SOLICITATION AMENDMENT
MODIFICATION DE L'INVITATION

Title - Sujet INTERNAL PA SYSTEMS	
Solicitation No. - N° de l'invitation 21120-127135/A	Amendment No. - N° modif. 004
Client Reference No. - N° de référence du client 21120-12-1687135	Date 2013-01-24
GETS Reference No. - N° de référence de SEAG PW-\$\$HN-313-61413	
File No. - N° de dossier hn313.21120-127135	CCC No./N° CCC - FMS No./N° VME
Solicitation Closes - L'invitation prend fin at - à 02:00 PM on - le 2013-02-28	
F.O.B. - F.A.B. Plant-Usine: <input type="checkbox"/> Destination: <input checked="" type="checkbox"/> Other-Autre: <input type="checkbox"/>	
Address Enquiries to: - Adresser toutes questions à: Kelly, Ruth	Buyer Id - Id de l'acheteur hn313
Telephone No. - N° de téléphone (819) 956-3588 ()	FAX No. - N° de FAX () -
Destination - of Goods, Services, and Construction: Destination - des biens, services et construction:

Amendment No. 004 is raised to provide Appendix 1.

APPENDIX 1***PA System for Use in Federal Correctional Institutions***

Additional technical elements at the Federal Training Centre (FTC):

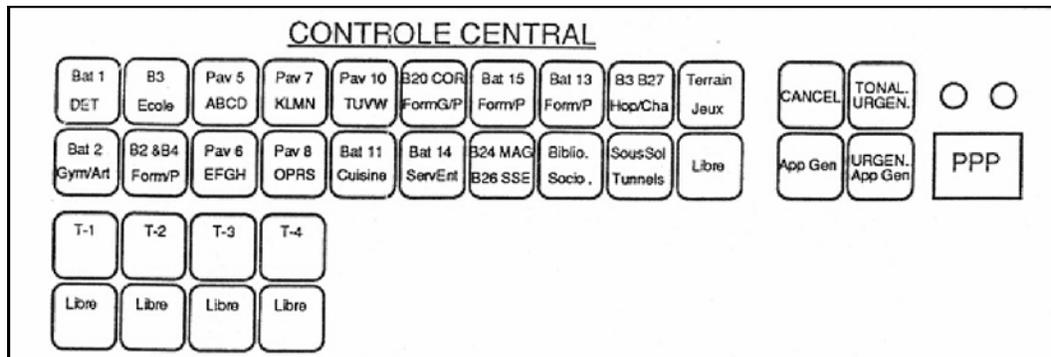
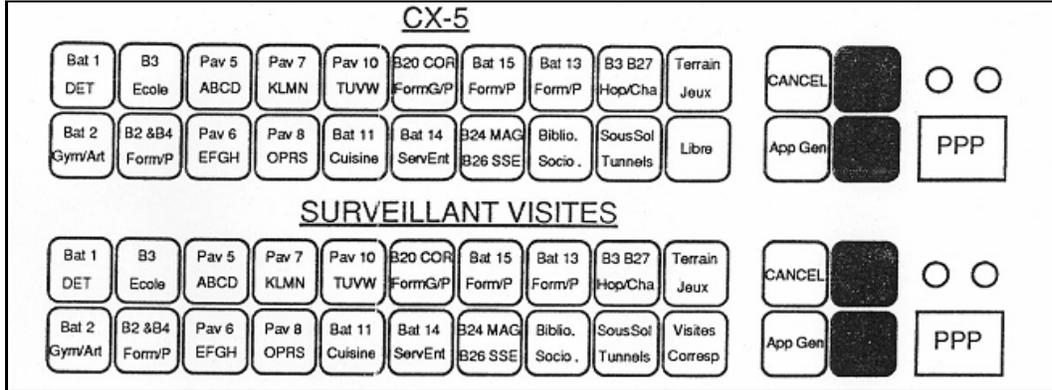
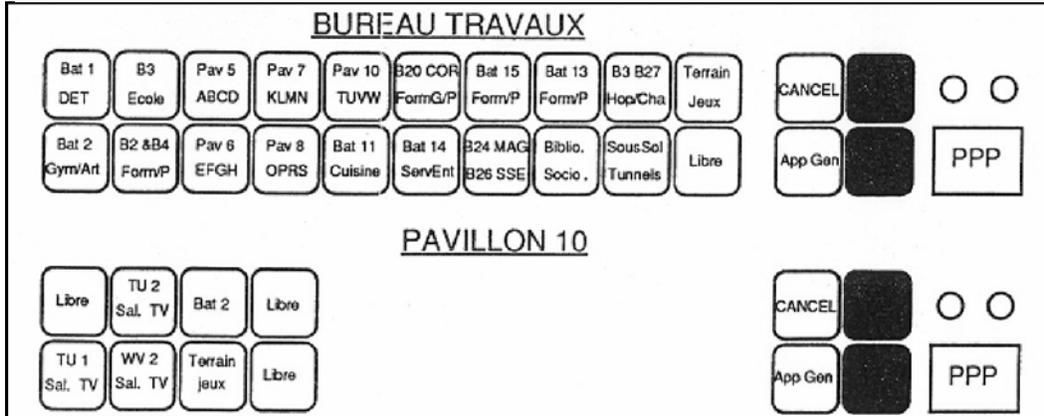
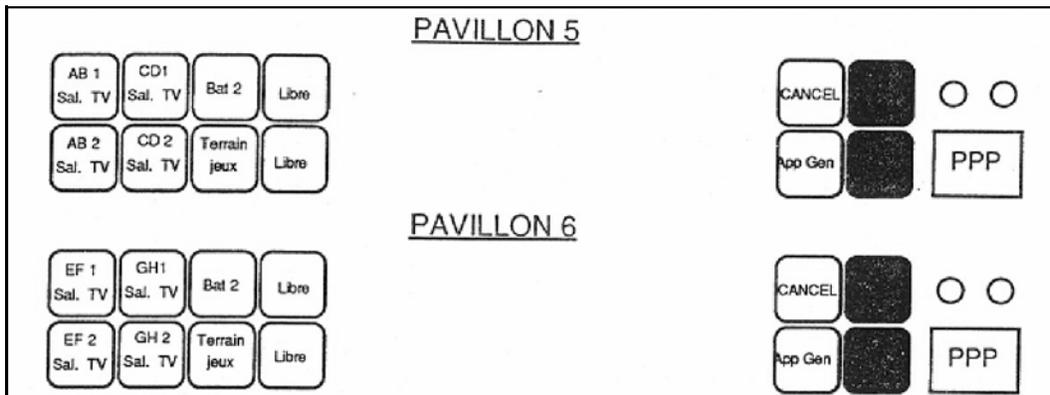
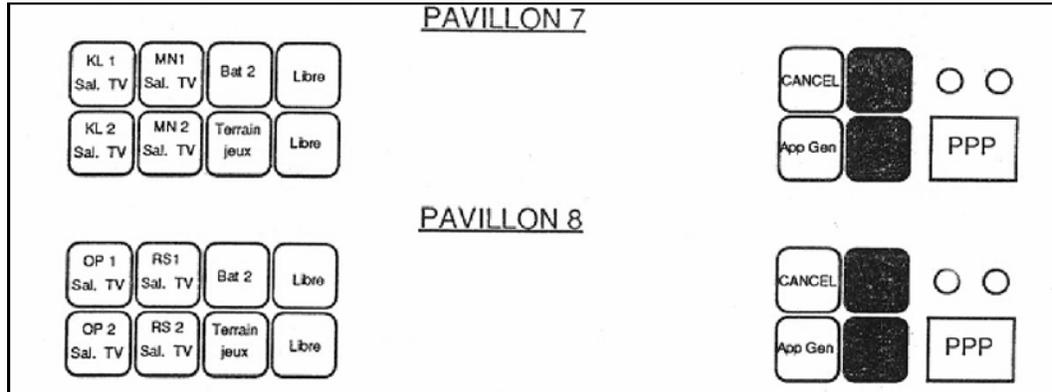
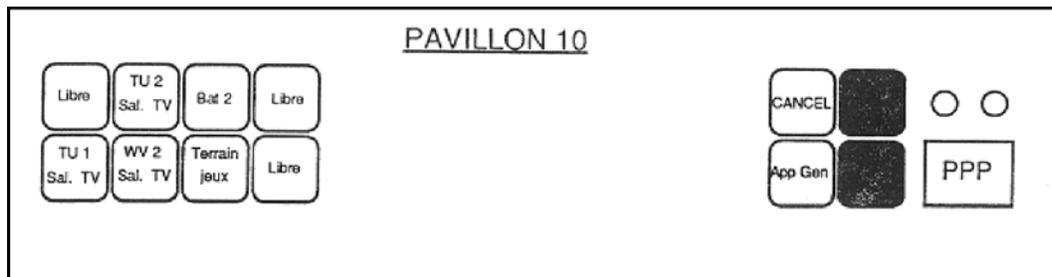
Section 7.1.2 of the STR features a description of the sector control posts currently being operated in the FTC.

During our site visit, we saw a local amplifier that was not connected to the main power box in room K3 of the institution's tunnel. In the basement of Building 26, we found an amplifier unit mounted to a support column. Two drawings of the institutions accompany this addendum: one showing the location of equipment and one showing schematics of the tunnels.

Additional technical elements for Cowansville

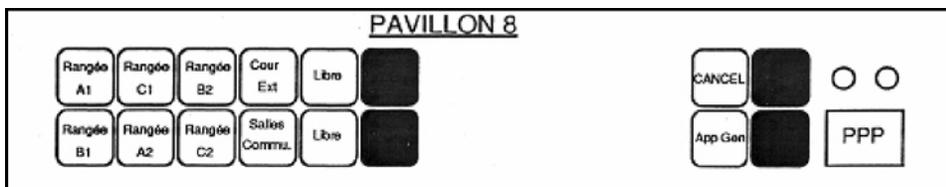
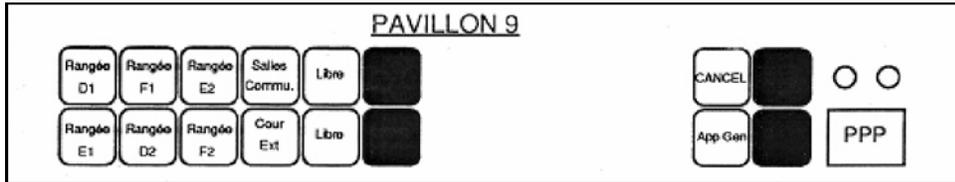
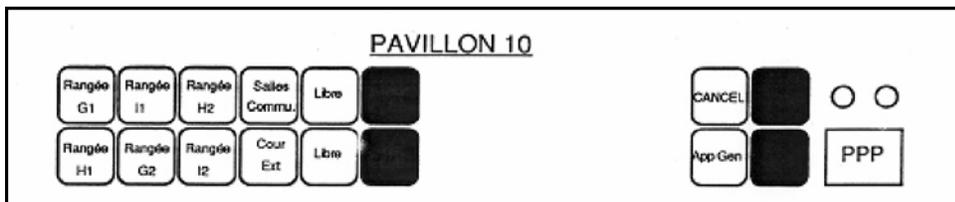
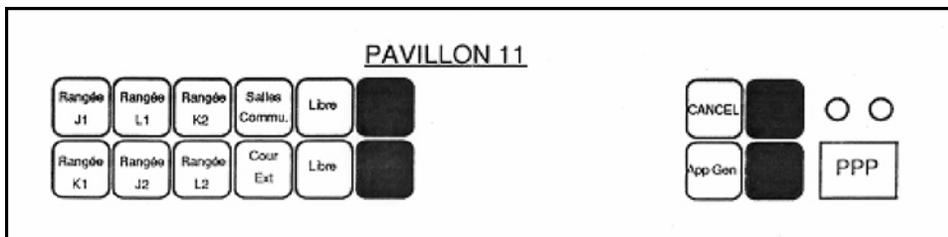
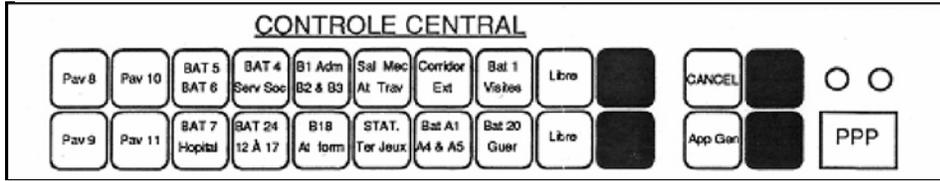
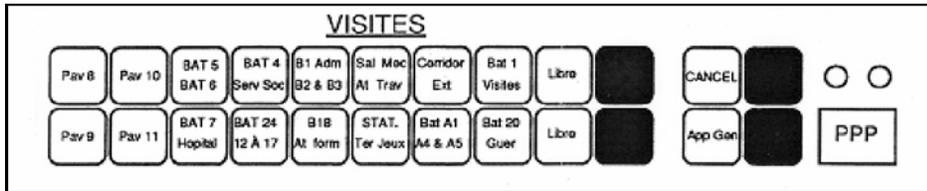
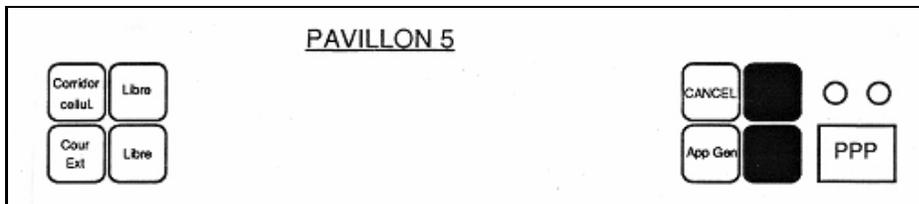
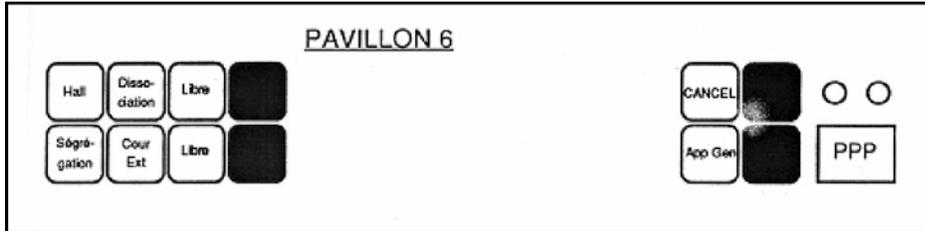
Section 7.5.2 mentions the installation of a PA control console. Only the sector telephone post will be used to activate the system. Please disregard the instruction in item 7.5.2 of the STR.

As stated at the beginning of this document, Cowansville requires fibre optic distribution in its infrastructures through conduits provided by CSC. The infrastructure is new (less than one year old) and available for use in 80% of the institution.

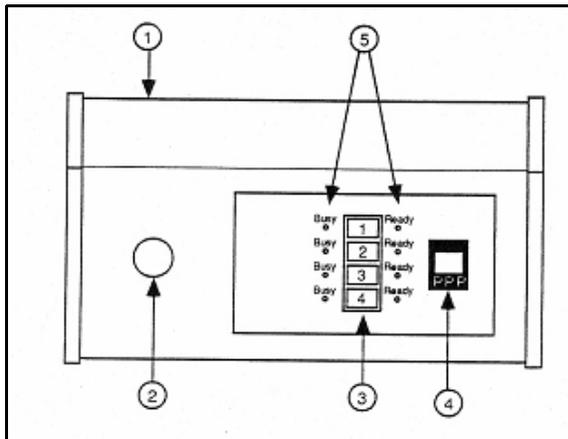
The project shall also include the two observation towers for outdoor activities (towers T2 and T5). Below is the type of control currently installed in the towers:

Additional technical elements for Archambault:

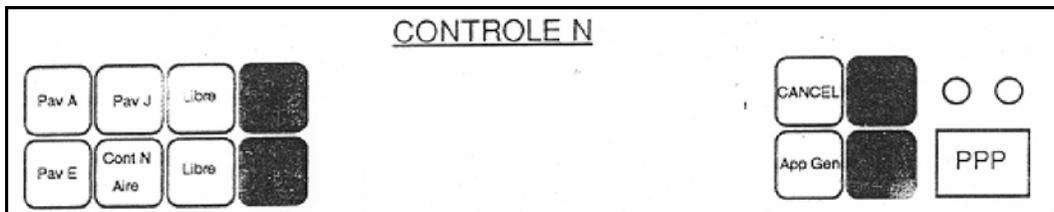
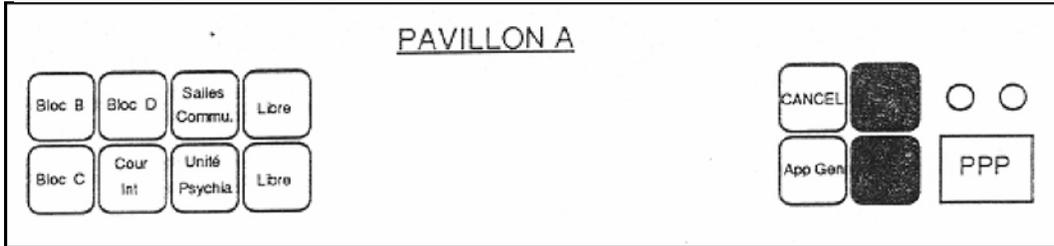
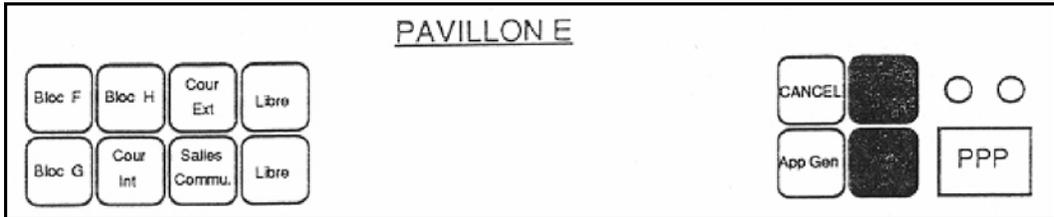
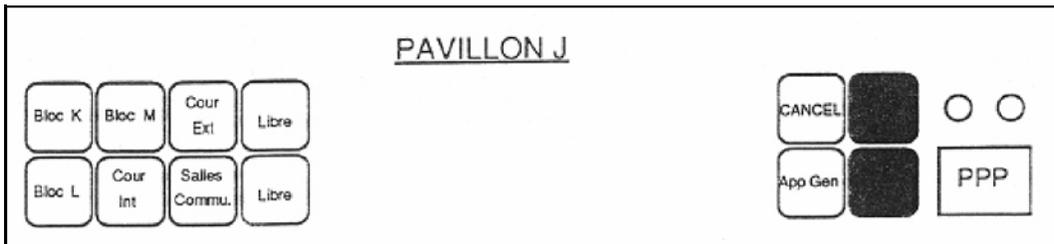
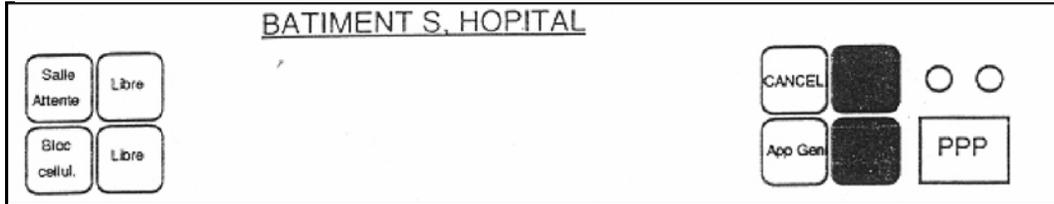
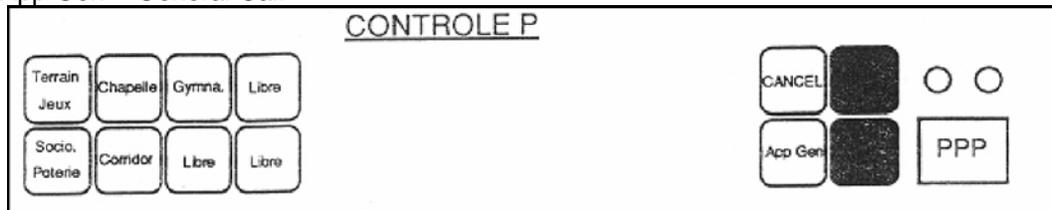
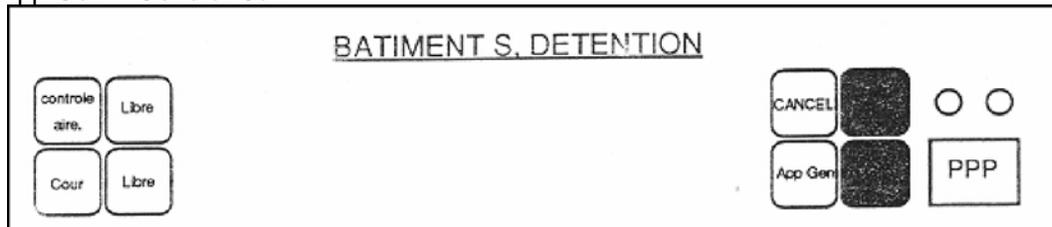
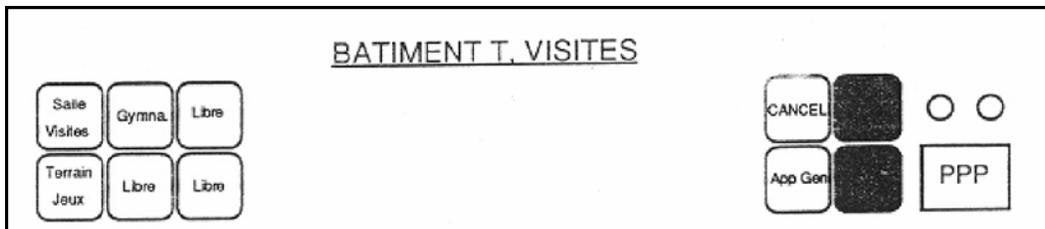
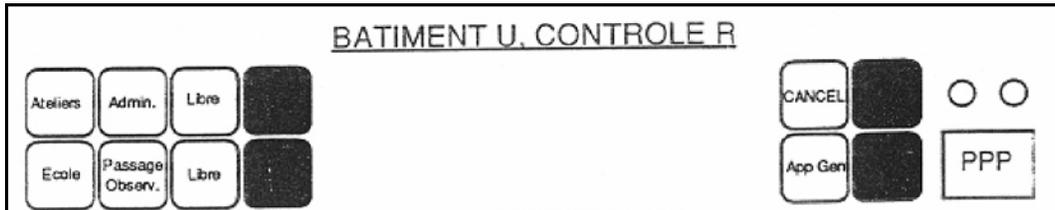
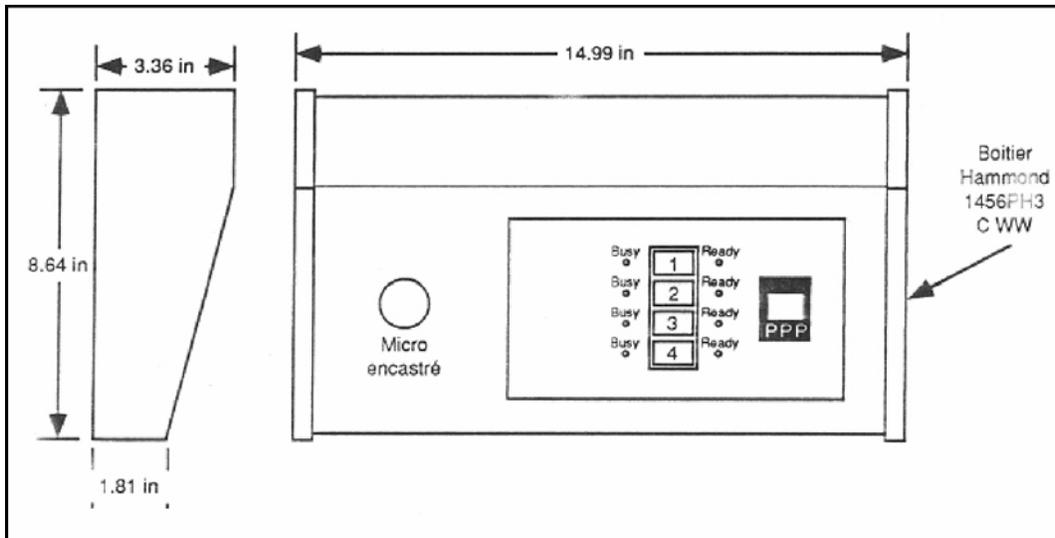
There are also four additional communications posts, for a total of 17. The four posts are similar to the ones shown above and are installed in towers T-1, T-2, T-3 and T-9.
